# Comments on applications for referral under the COVID-19 Recovery (Fast-track Consenting) Act 2020

Project name	Ngongotahā Housing Development, 31 Ngongotahā Road, Rotorua
General comment – potential benefits	<p>The project will result in the construction of 196 household units with a mix of affordable housing and social housing. It is acknowledged that there is a housing shortage within the Rotorua District and there will also be economic benefits from the proposal.</p> <p>The project will also involve the construction of pedestrian and cycle accessways, public open spaces, restoration planting (adjacent to the riparian corridor), stormwater reserves and a wetland.</p>
General comment – significant issues	<p><b>Staged Approach to the Development of the Site</b></p> <p>We have previously provided the following advice to the applicant. This is contained within the technical memo also attached to this response.</p> <p><i>In recent times, the Rotorua area has been subject to a number of larger flooding events with significant consequences including the nearby Ngongotahā and Utuhina catchments. This has prompted BOPRC to carefully consider the impacts of proposals to urbanise land,

Figure 1: Proposed Staging of the Development

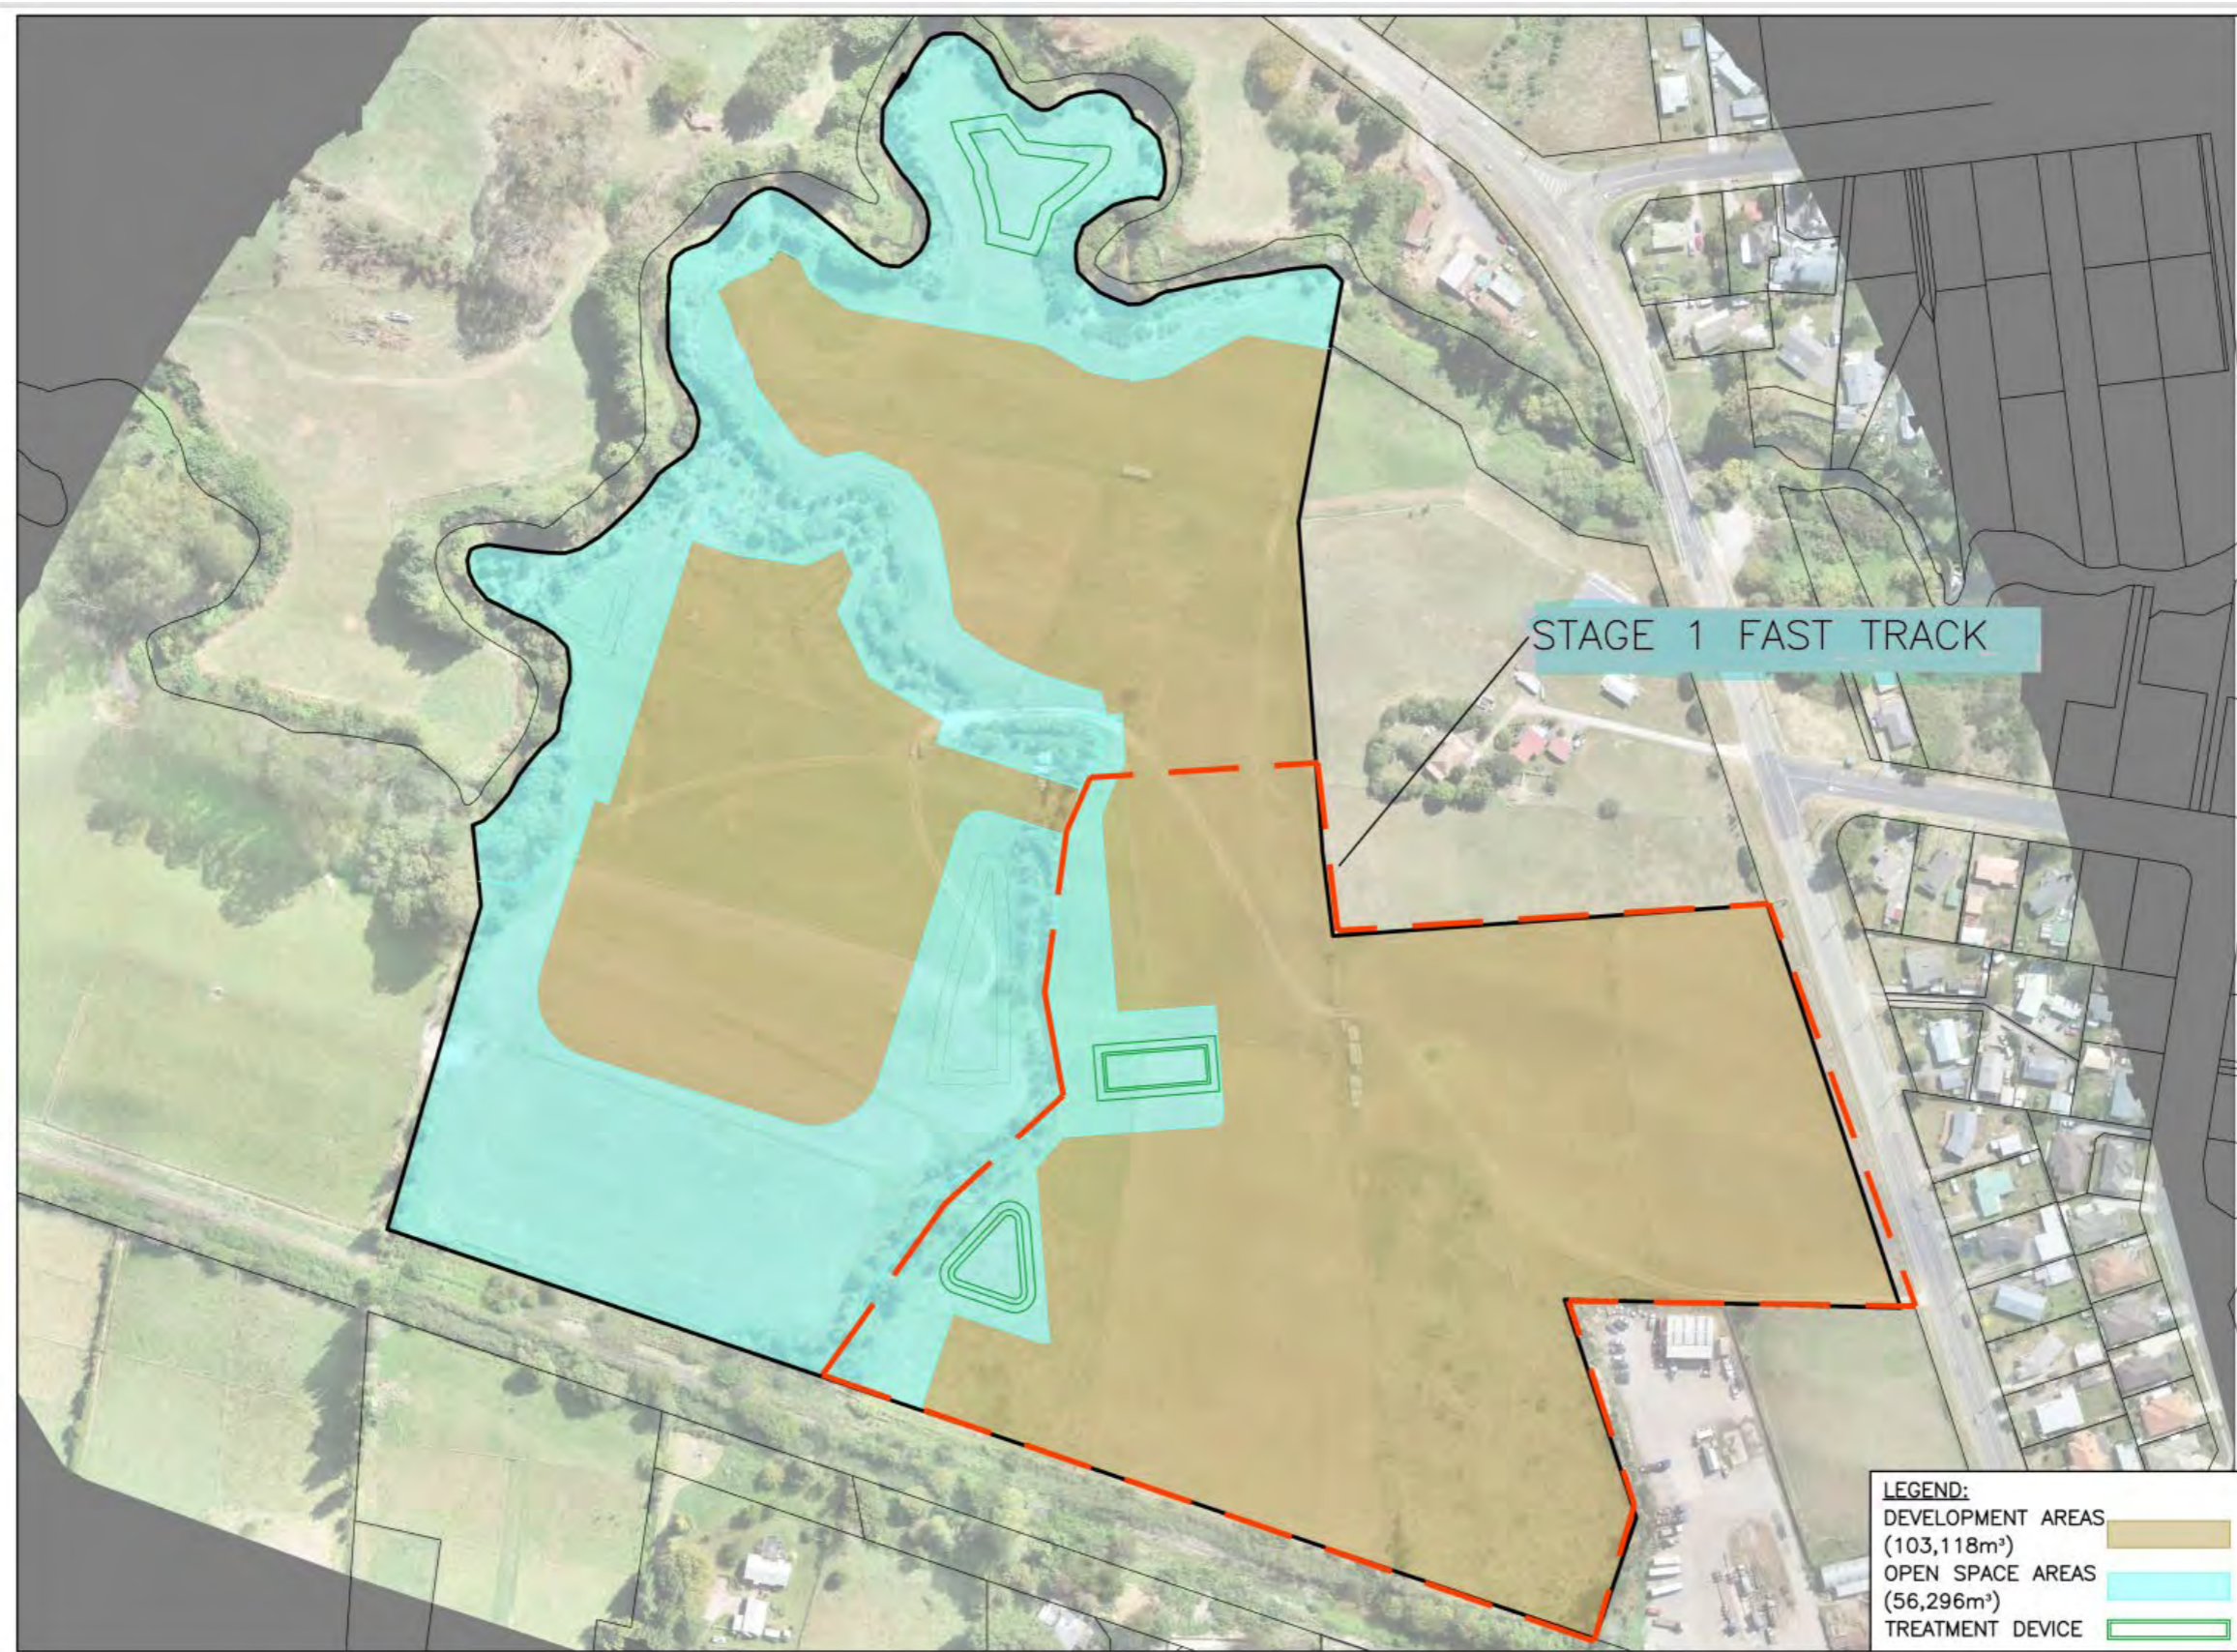
recommend that the effects associated with development the entire site (such as the density of development, impervious coverage, stormwater management and flooding effects) are considered and that the interdependency between the proposed staging with regards to stormwater management is better defined. We note that little information has been provided on this aspect to date. **(See Figure 1 on Page 6 for the proposed staging of the development).**

Figure 2A: Extract from RLC Spatial Plan (Ngongotahā)

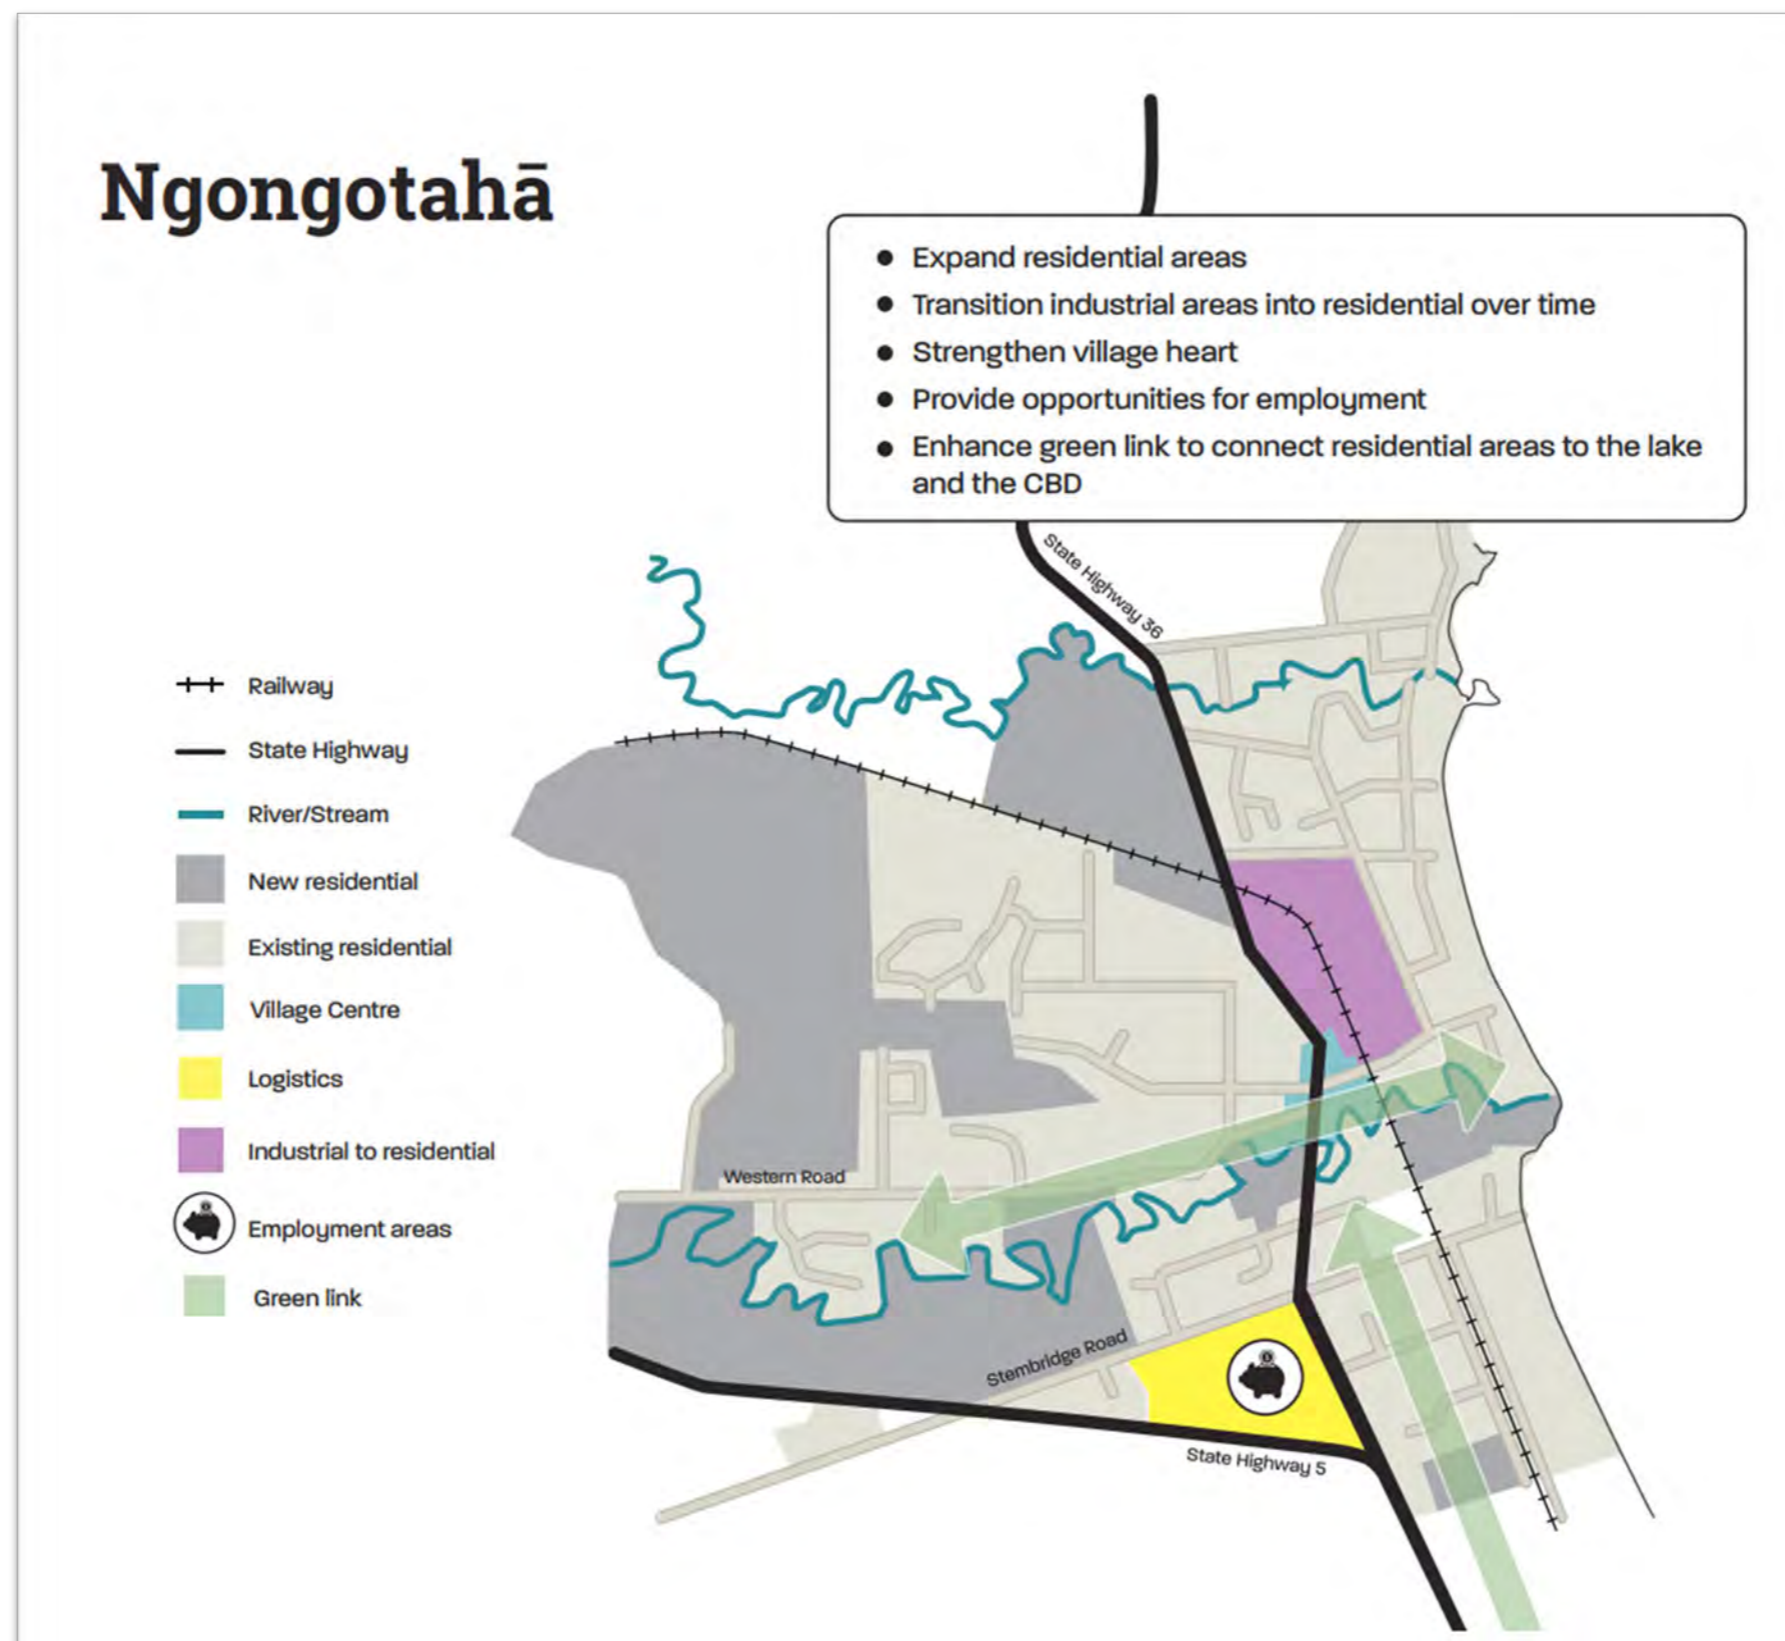
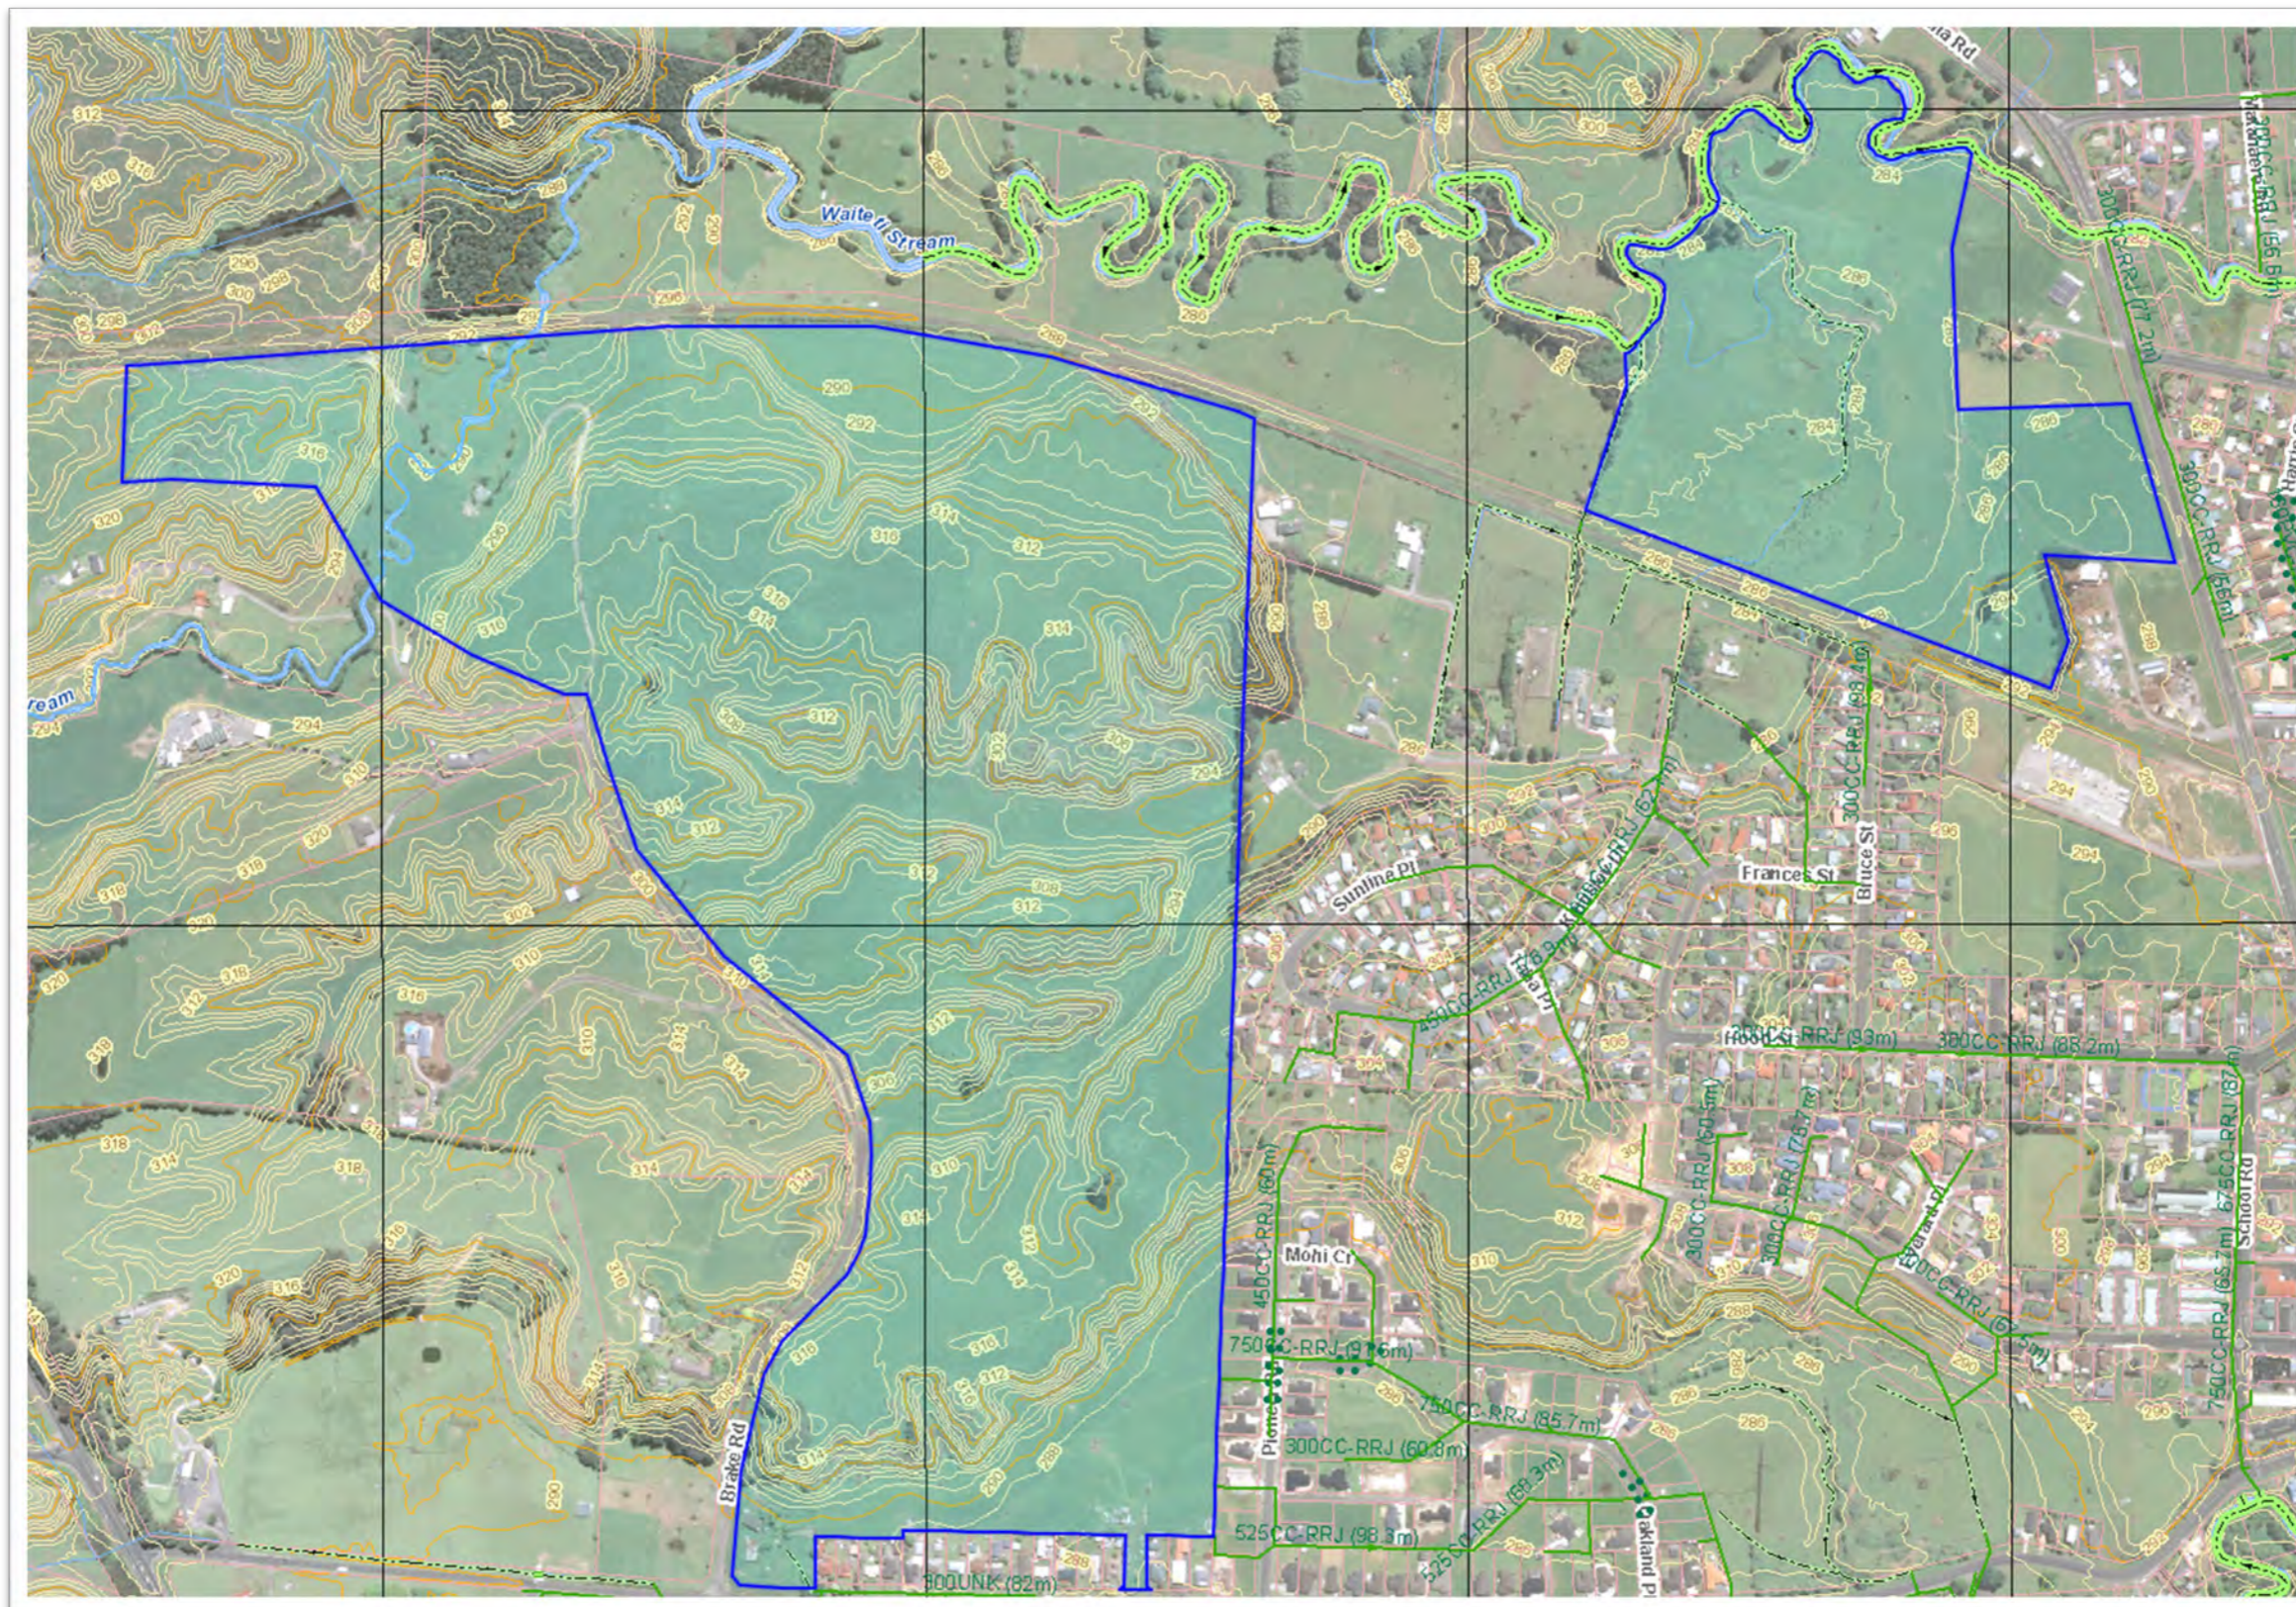
We have some concerns about the assumptions that have been made in the stormwater modelling for the impervious coverage for the contributing catchment. It appears that the impervious coverage for 124 Western Road this area was assumed to be 0% impervious in the updated “PDP modelling and flood assessment report for 31 Ngongotahā Road dated 29 April 2021” which appears to mean that PDP assumed that there will be no increase in stormwater runoff from 124 Western Road when developed. However, this has not been assessed and proven. Further, the impervious coverage for the existing residential 1 areas, south of the proposed residential development (on the other side of the railway embankment) was assumed to be 50% in the updated PDP modelling report, whereas the permitted impervious coverage for residential 1 zone in the Rotorua District Plan is 80% which should be used in the modelling. **(See Figures 2A, 2B, 2C & 2D on Pages 7- 10).**

Should the assumptions in the modelling be less than that permitted under the District Plan for the relevant zone, please provide further information as to how the developer/applicant proposes to manage the restrictions regarding impervious areas and the mechanism for achieving this. We have concerns regarding the assumptions made through the modelling process versus what is allowable on site. This could be further complicated if the Western Road and Ngongotaha Road sites are developed by different parties and could affect the consent process regarding the identification of affected parties and potential notification.
